## **Proposal for the 01 Series of amendments to UN Regulation No. 35 (Foot Controls)**

This proposal aims at clarifying the measurement method for the lateral distances of the pedals to the nearest "wall" to the left. The modifications to the current text of the regulation are marked in bold for new or strikethrough for deleted characters.

"5. Brief description of the vehicle type as regards the arrangement of foot controls **and foot rest**....."

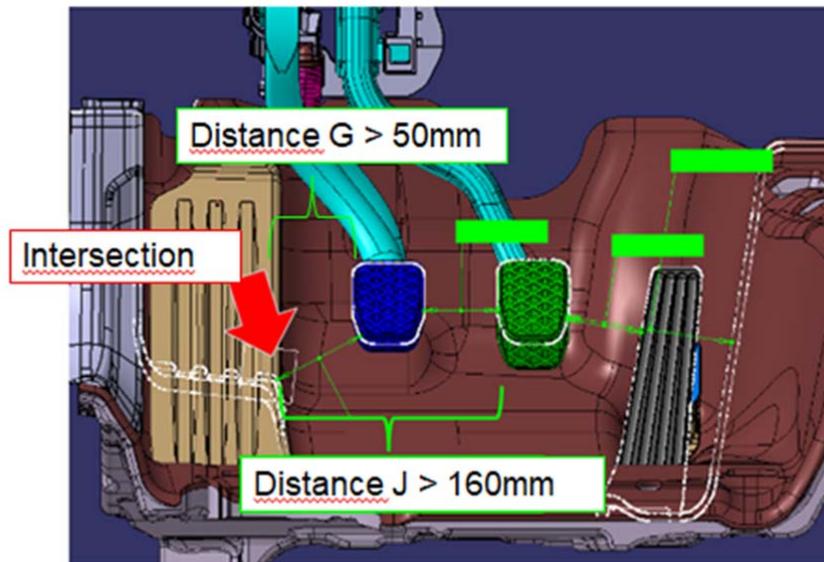
**In case of a foot rest as declared by the manufacturer, installed for the driver's left foot the shortest distance between the most left pedal and the wall shall be measured above the foot rest, and the minimum distance between the projection of the most left pedal and that foot rest on to the reference plane "P" shall be  $\geq 50\text{mm}$ .**"

*Annex 1, Item 5*, amend to read:

Three-pedals - Conventional transmission

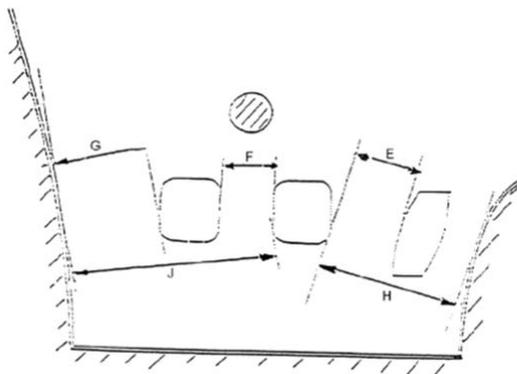
"5.7. The distances, respectively shown as "H" and "J" in annex 4, between the projection of the service-brake pedal on to the reference plane "P" and the intersection of each of the walls with that plane shall be  $\geq 130\text{mm}$  to the right and  $\geq 160\text{mm}$  to the left for vehicles with three pedals, and  $\geq 130\text{mm}$  to the right and  $\geq 120\text{mm}$  to the left for vehicles with two pedals.
